**RE: MINOR CHANGE TO EXISTING APPROVAL UPON LAND AT 6 JOSLING STREET & 73 BRISBANE STREET, TOOWONG QLD 4066**

We write on behalf of the applicant, *Josling Toowong Pty Ltd* requesting a Minor Change to the existing Development Permit (A006604044).

## MINOR CHANGE APPLICATION

Figure 3: Proposed amended ground floor plan

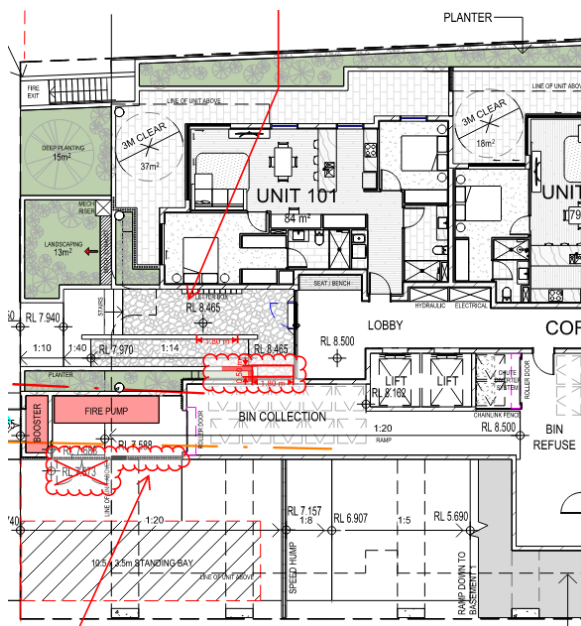
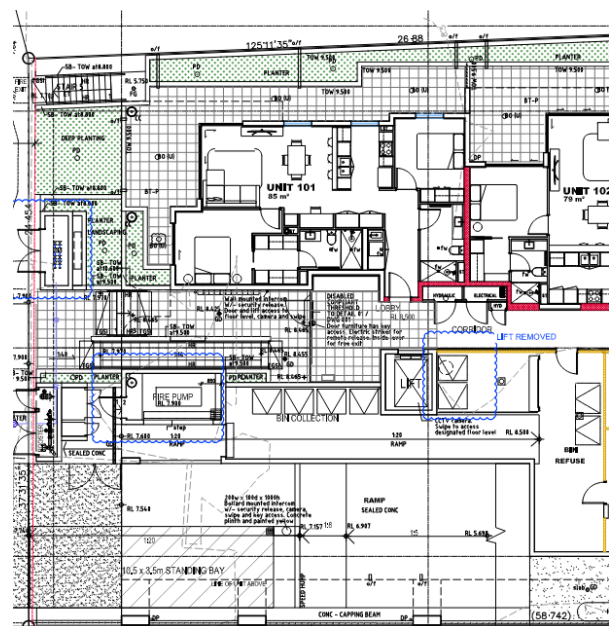
Amendments on the ground floor level are limited to minor service relocations and internal alterations that do not impact the overall building footprint or function. This includes:

- Relocation of fire pump room to improve servicing efficiency;
- Mechanical exhaust along site frontage to service ventilation from the underground basements;
- Access clearance into the site has been reduced to a height of 3.98m;
- Removal of the second lift which creates additional internal area, expanding the bin chute enclosure across each level; and
- A roller shutter door is included to limit access to residents and bona fide visitors to provide improved security to the development.

Additionally, the front landscape planter has been extended in direct response to Council's amendments in red on the approved drawings. As a whole, it is considered the ground floor changes are minor in nature and do not result in any major alterations to the approved design as illustrated in Figure 2 and Figure 3.

Figure 5: Proposed amended typical floor level 2-4 showing removed second lift and removed balcony of Unit 204

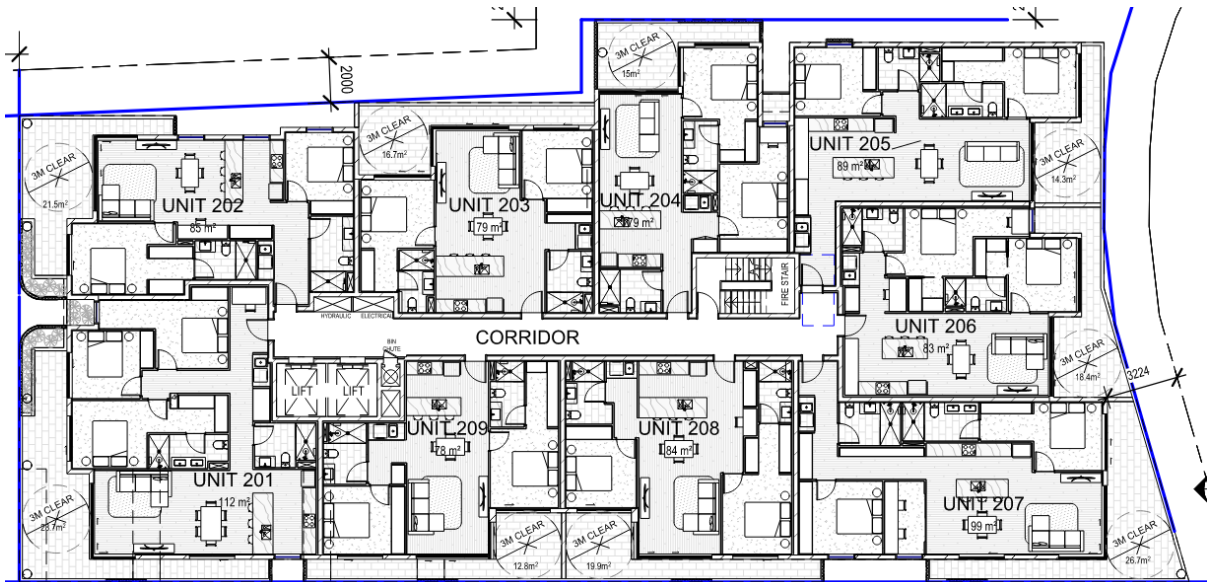
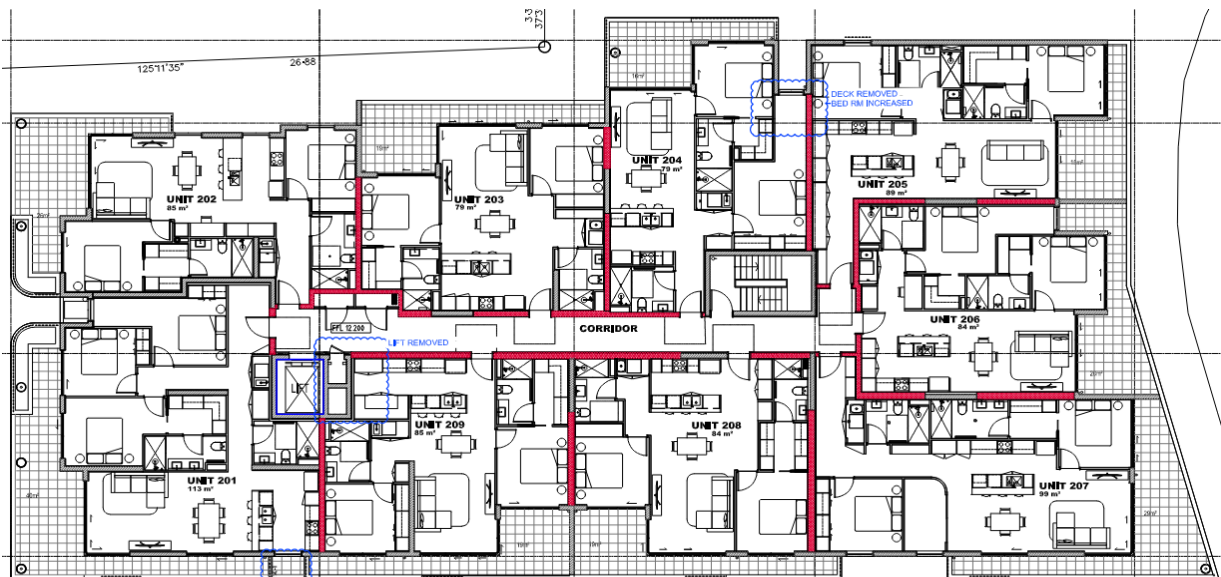
As a result of the bin chute redesign on each level, Units 209, 309, 409, and 509 now include minor increases in floor area. Furthermore, removal of bedroom balconies in Units 204, 304, and 404 allows for improved internal bedroom layouts. These changes are internal and minor, with no negative impacts on building

Changes at Level 2 are confined to a nominal extension of the western boundary deck at Unit 201. This adjustment is very minor and does not change the appearance of the building. It is extended to create further cohesion with the design and building façade along the western elevation and remains consistent with the established building envelope.

Figure 7: Proposed amended level 5 and communal open space plan

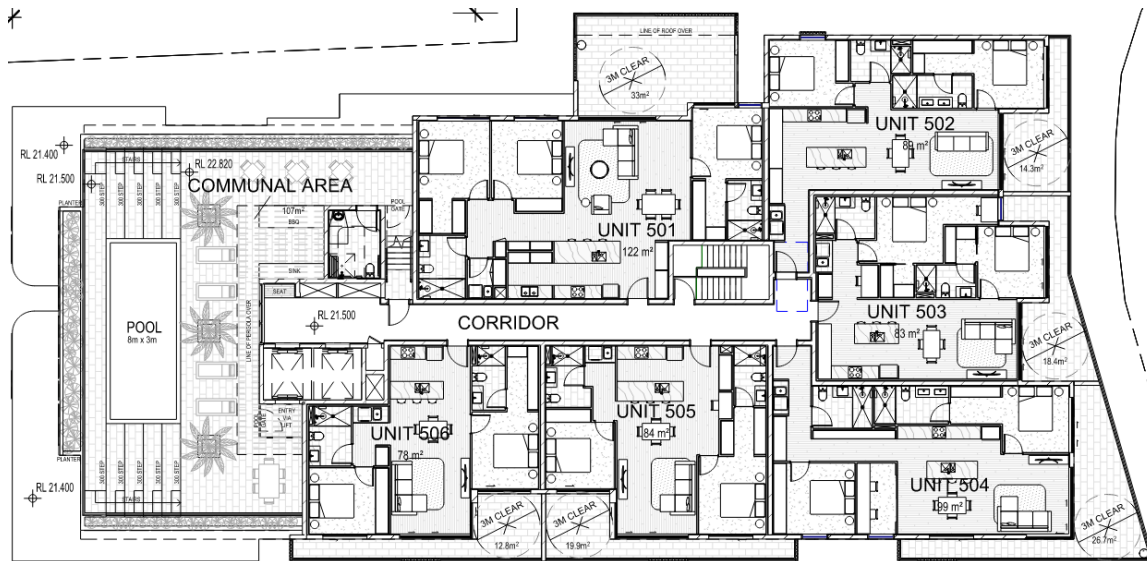
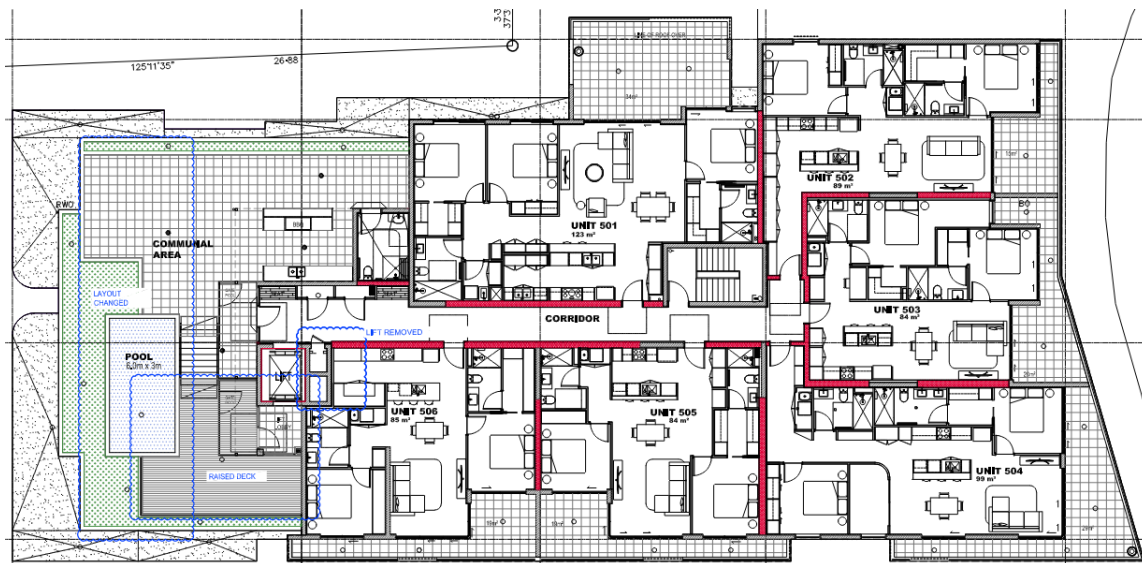
The communal open space (COS) upon Level 5 has been further refined as part of the detailed design process. Specifically, the pool now provides a 6m x 3m dimension, with expanded landscaped planters located to the front boundary (north) to increase the privacy of recreational users and provide additional visual amenity within the development and to the streetscape.

Additionally, a raised deck has been incorporated to provide access to the pool area as it will be located above the finished floor level of the roof. The previously approved design resulted in the majority of the communal outdoor space being above the internal floor level. As such, this revised arrangement results in a more

functional communal area that provides a level transition with the indoor spaces and lift lobby, and also allows for a larger BBQ, outdoor kitchen and dining area without increasing the overall intensity or scale of development.

Furthermore, as illustrated in Figure 7 and as detailed above, the rooftop communal area proposes additional containerised planting area from that approved. The increased width of the planting area will ensure longevity of planted species. The outcome of the landscaping is generally in keeping with the approved landscape concept plan and Condition 59 and 60 of the approval.

Figure 8: Proposed amended ground floor plan with landscaping areas highlighted in green demonstrating consistency with approval

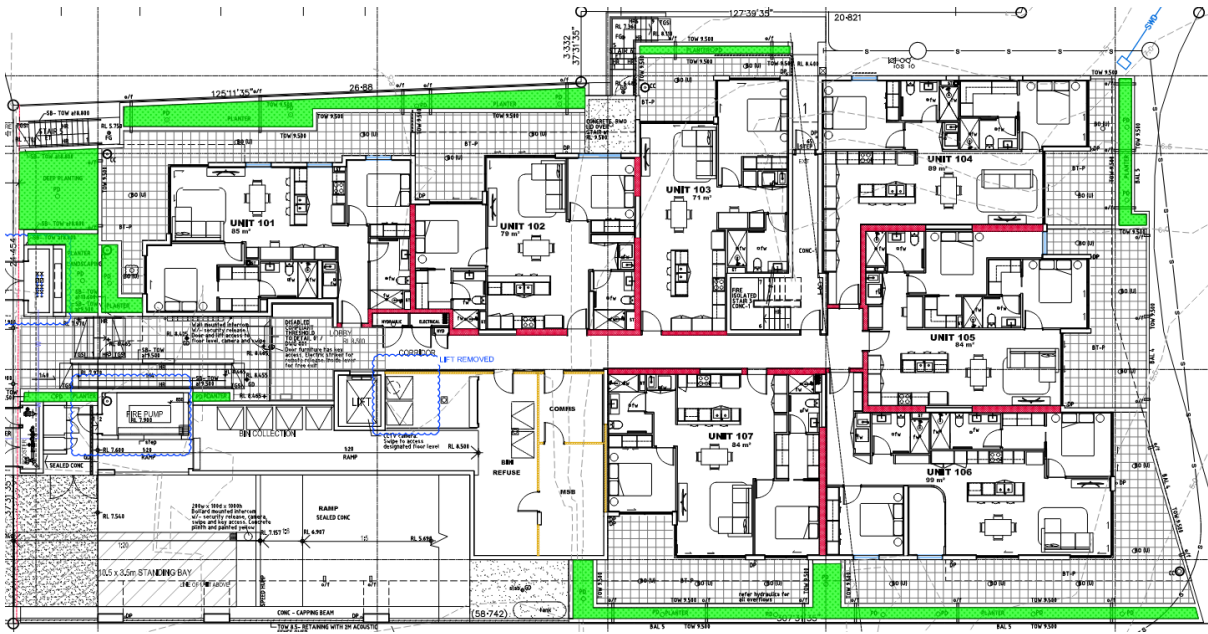
Specifically, the deep planting area on ground level adjoining the front verge is maintained to be planted with a feature tree, shrubs and groundcovers in accordance with the approval. This deep planting area has an unobstructed soil depth consistent with the current approval.

Figure 9: Elevation Plans – Approved and Proposed Comparison

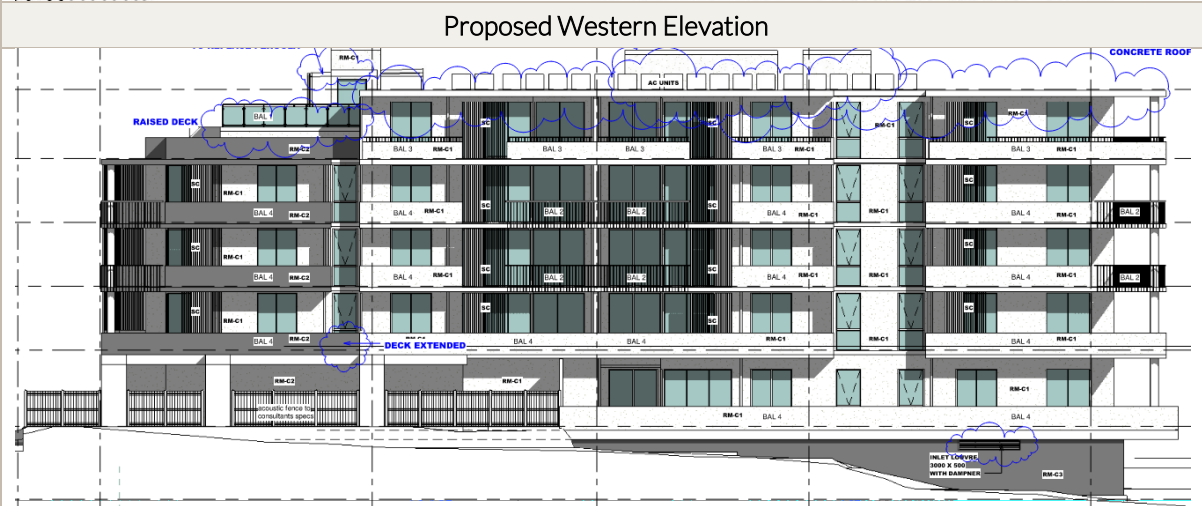
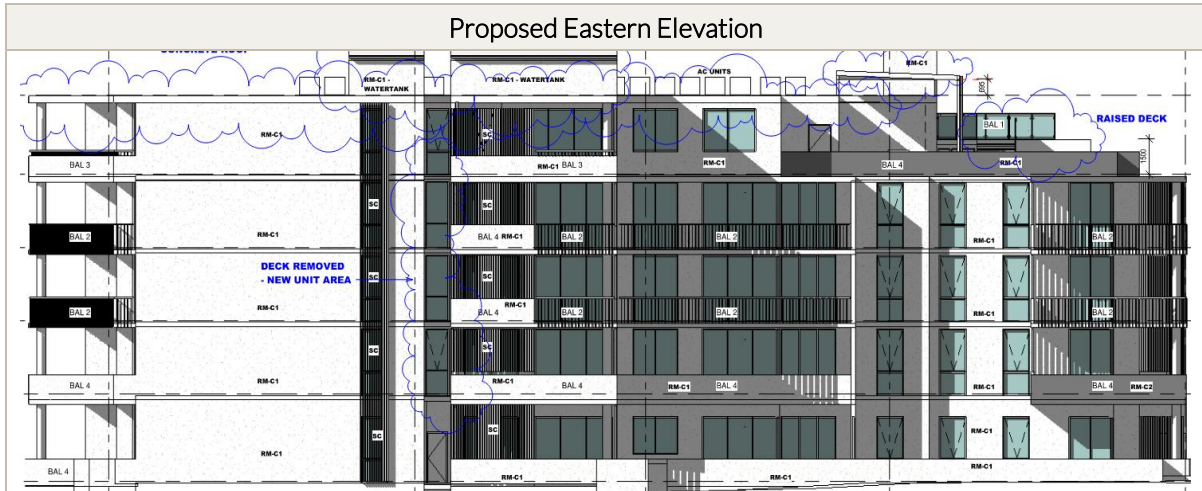
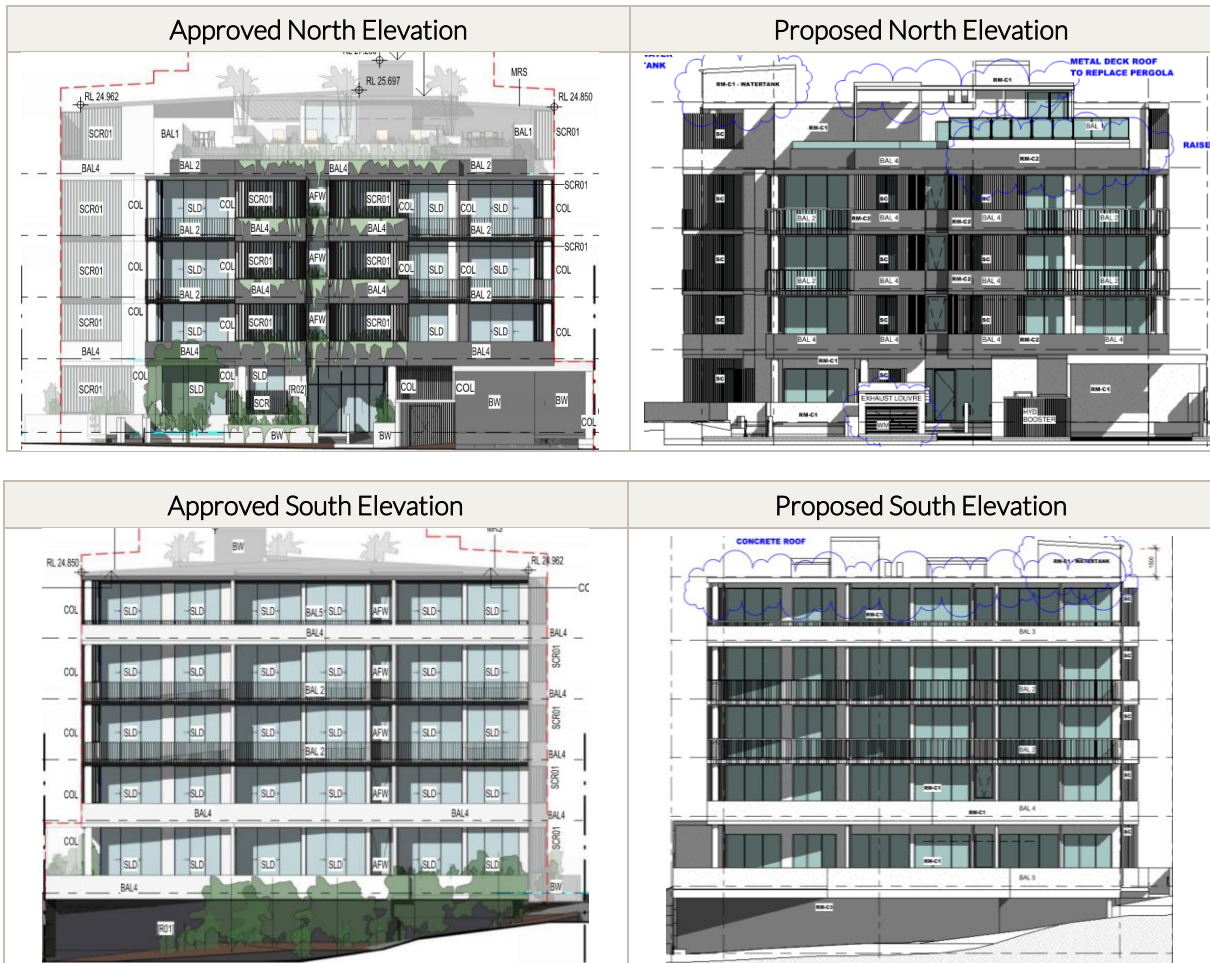
The proposed amendments upon the roof seek to remove the pitched roof to facilitate the provision of plant and equipment within the roof area. A flat, concrete roof is proposed to accommodate air conditioning units which will be screened from view in accordance with Condition 57 and 61 of the approval. Furthermore, two fire water tanks are proposed on the rooftop along the north-east edge of the building, to be fully enclosed and roofed and integrated within the building form. The height of these tanks do not exceed the height of the approved lift core, ensuring the built form remains contained within the approved building envelope.

In addition, previously approved pergola roof over the communal open space is proposed to be replaced with a metal deck roof structure. The amended roof improves the functionality of the rooftop open space by providing additional sun and weather protection.

Despite the abovementioned changes, the external appearance of the development remains generally consistent with the approval. The minor changes to the development's internal layouts, as noted above, do not adversely change the approved material and façade presentation. Furthermore, the most identifiable changes in the elevations relate to the change in the pitched roof to a flat roof to accommodate building services. Notwithstanding, these services are screened from view and will not change the visual appearance of the building from a public pedestrian viewpoint.
